BID
ADDENDUM NO. 3
TO
CONTRACT DOCUMENTS
AND
TECHNICAL SPECIFICATIONS
FOR
2019 BOND REFERENDUM
CAPITAL IMPROVEMENTS
AT
MAMARONECK HIGH SCHOOL
PHASE 2
NYSED #66-07-01-03-0-001-039
BID # 20/21 – MUFSD-00

Mamaroneck Union Free School District
1000 West Boston Post Road
Mamaroneck, NY 10543

LAN Job #4.1092.72.06
January 7, 2022

MECHANICAL PROPOSED PLAN
CAPITAL IMPROVEMENTS AT
MAMARONECK HIGH SCHOOL
MAMARONECK UNION FREE SCHOOL DISTRICT
1000 BOSTON POST ROAD, MAMARONECK, NY 10543
Job No. 4.1092.72.6
File No. 10927206M220
M2.21

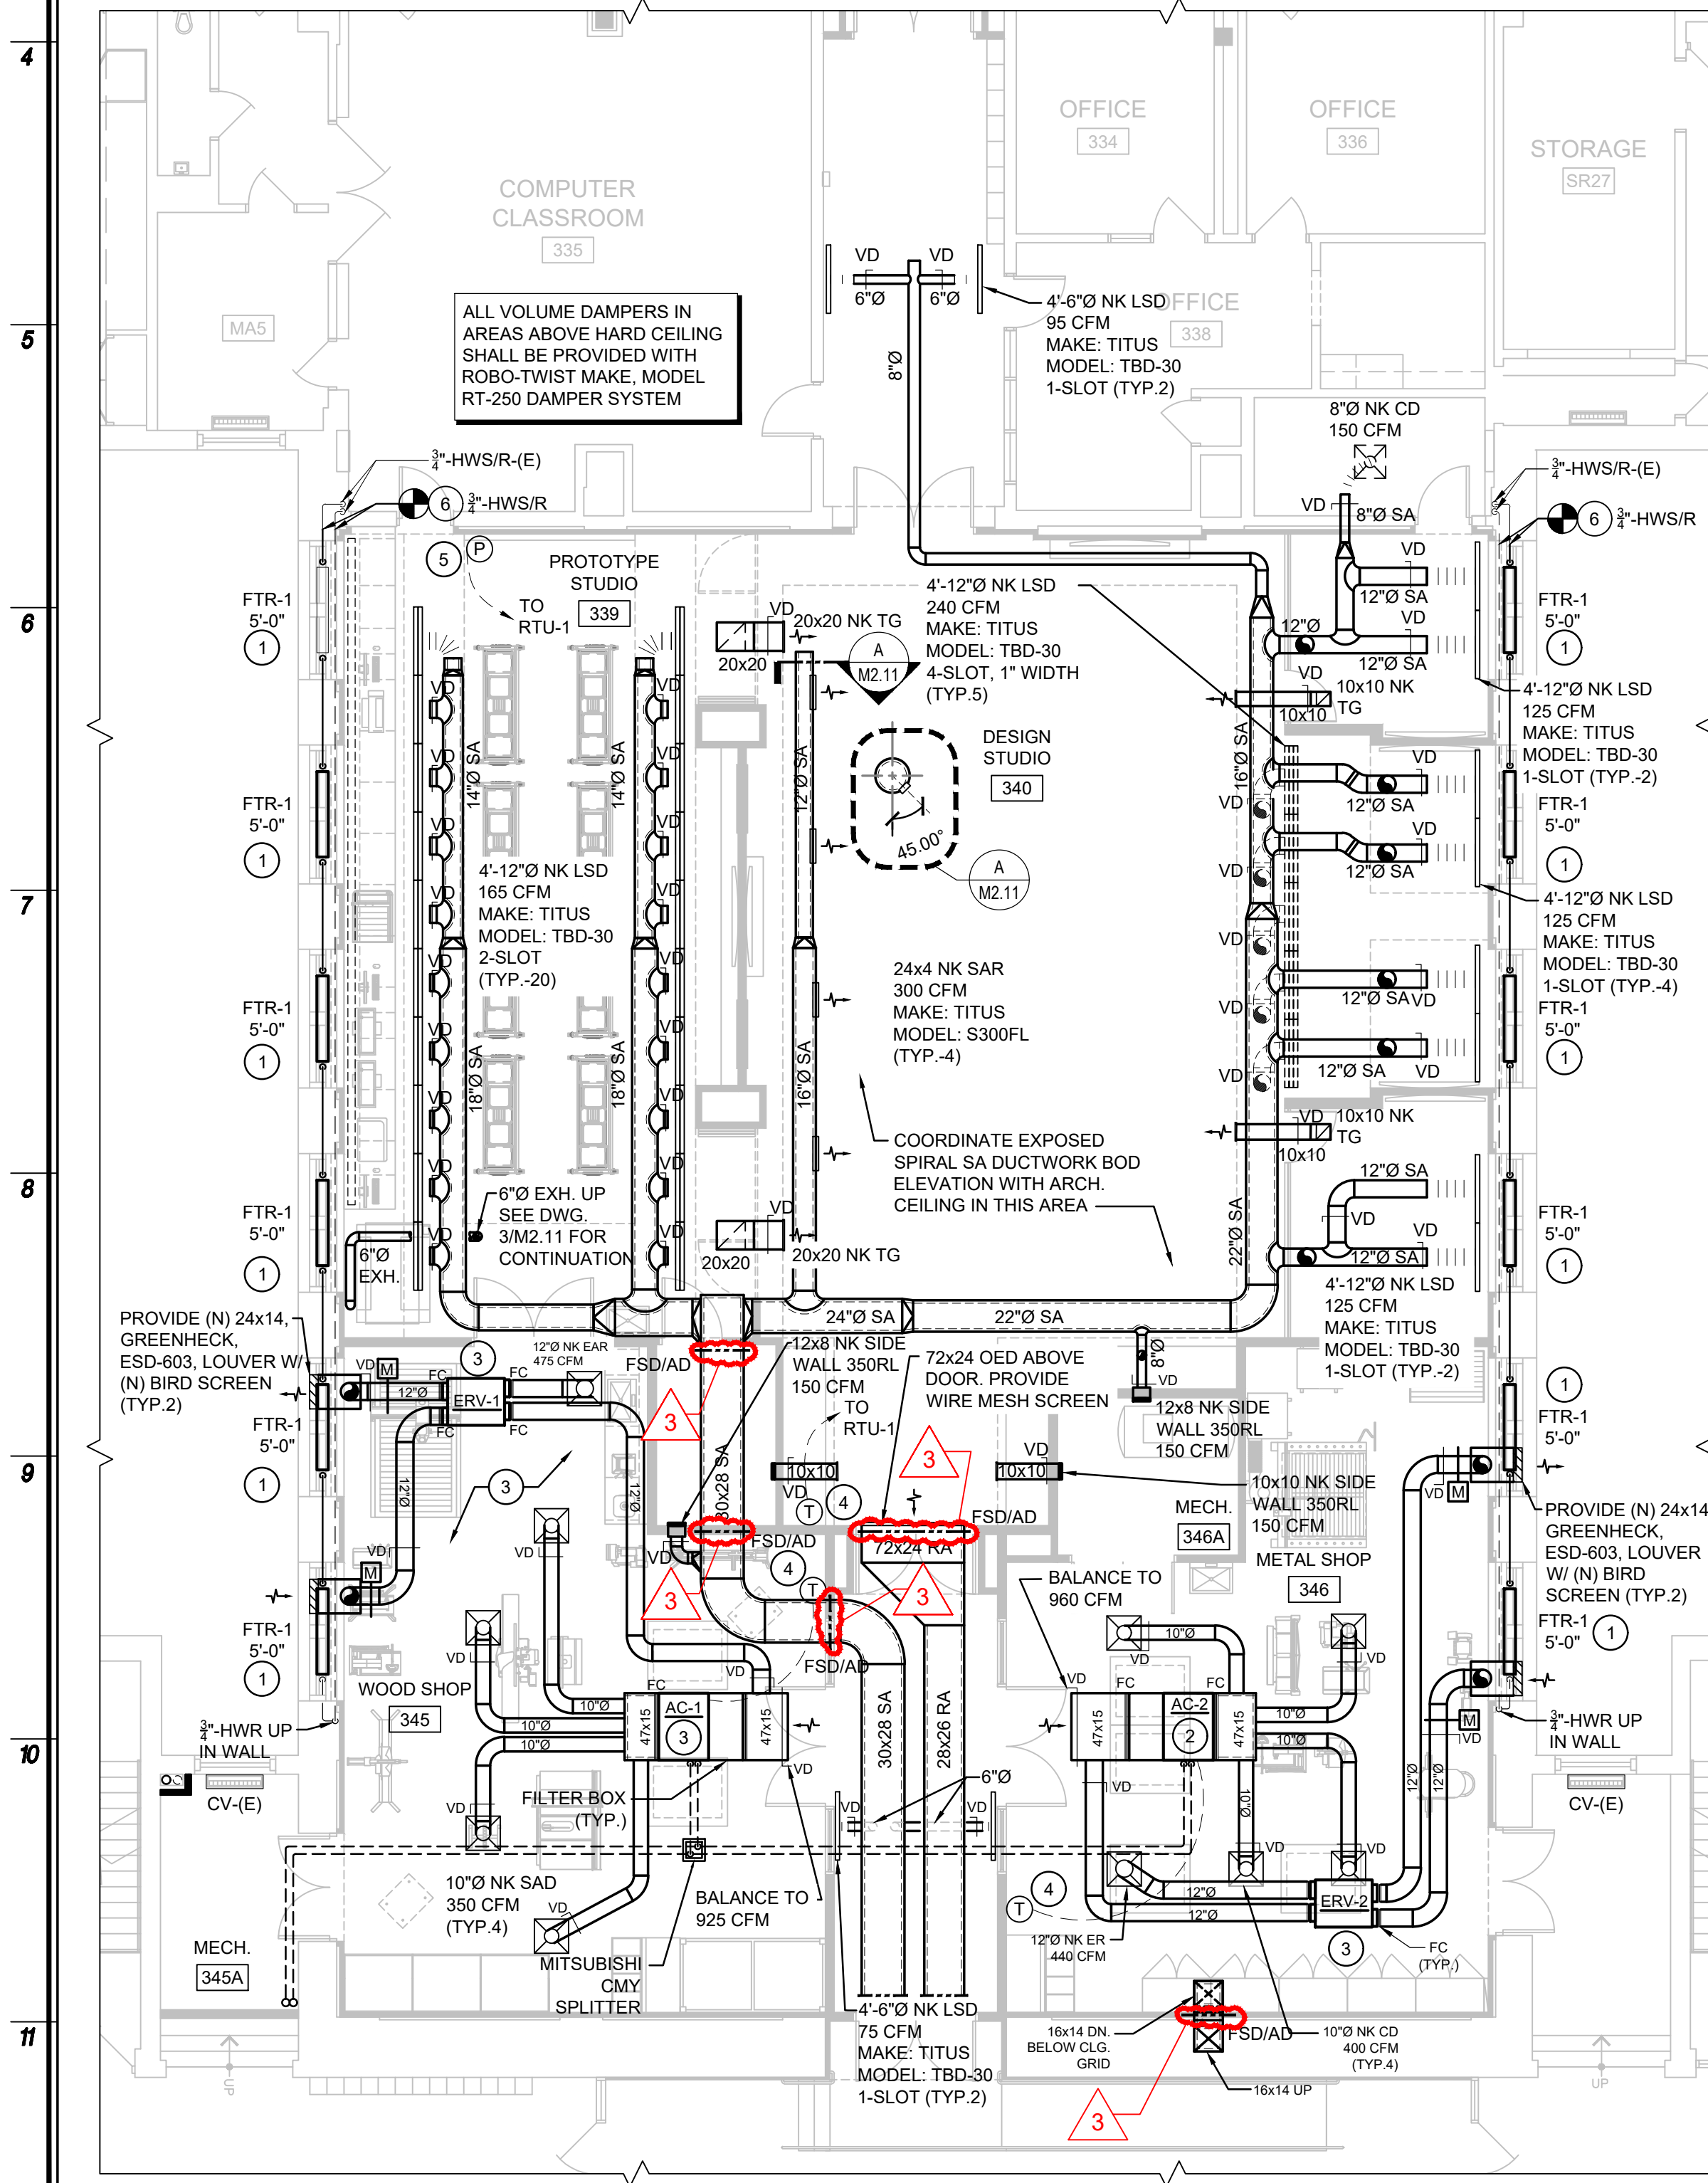
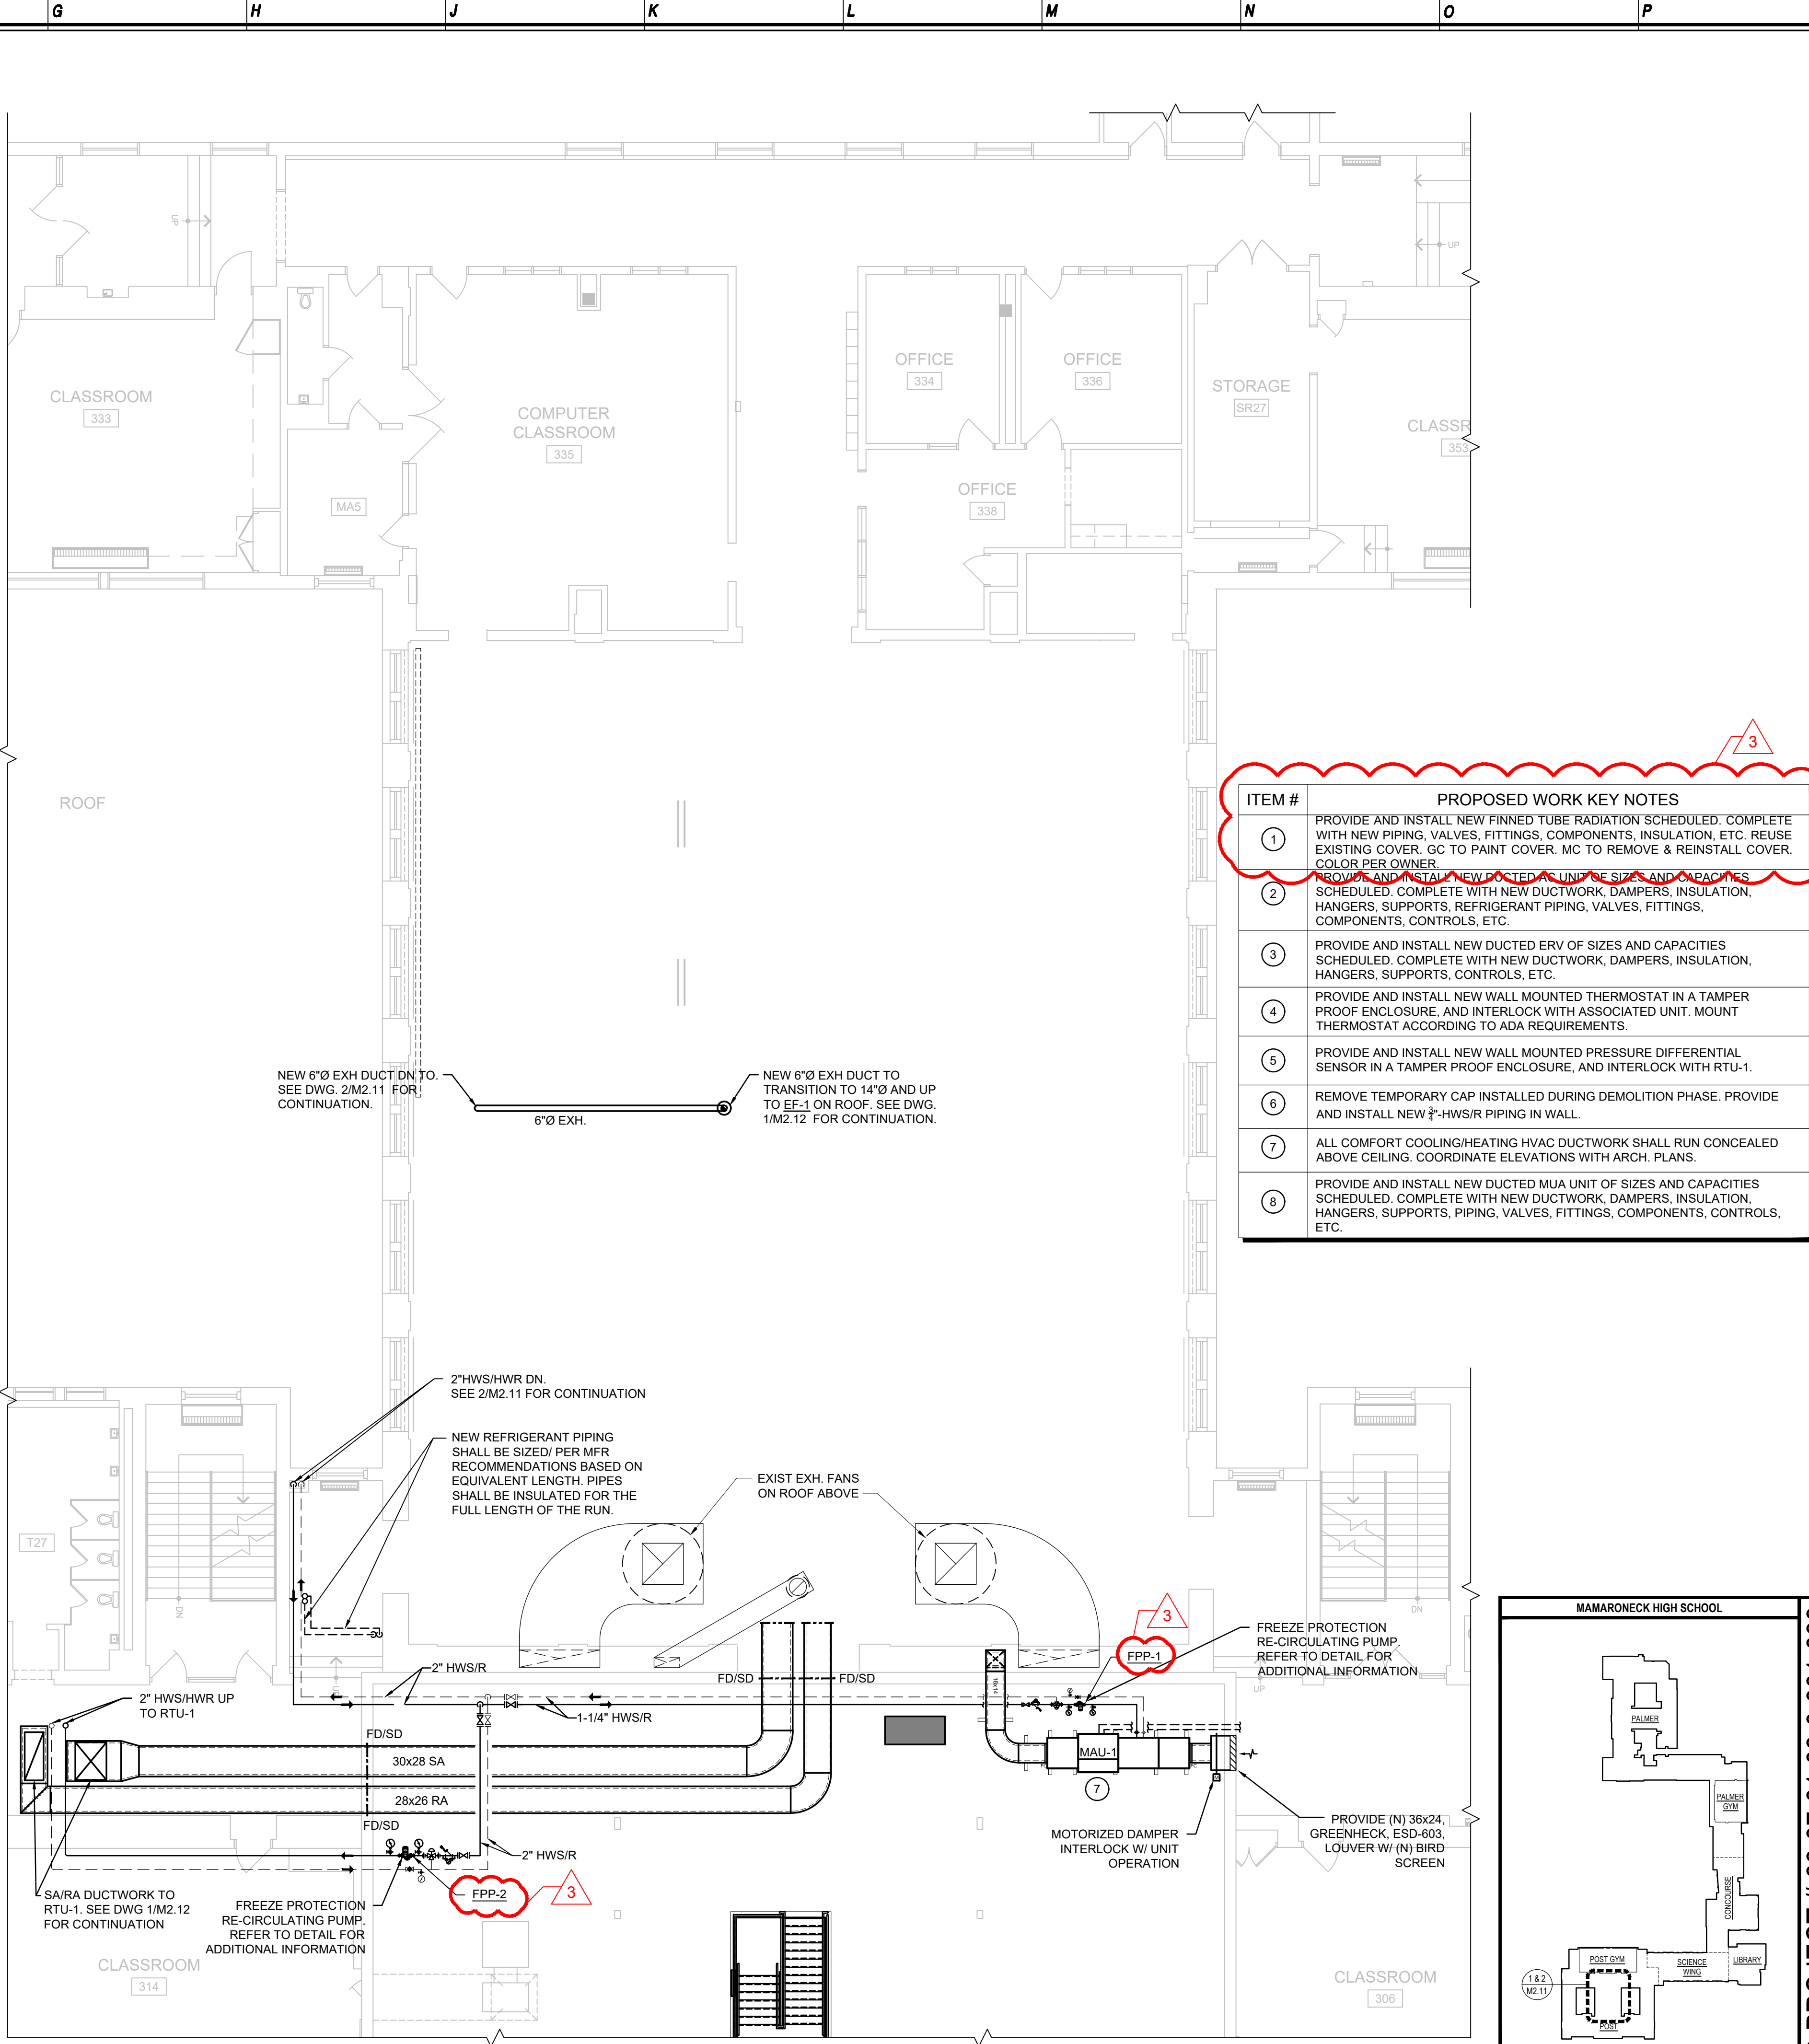
- 4 Question: M2.21 – Please clarify pipe diameters for pipes scheduled to get Metraflex expansion bellows.
- Response: Drawing M2.21 has been updated to reflect the pipe diameters.
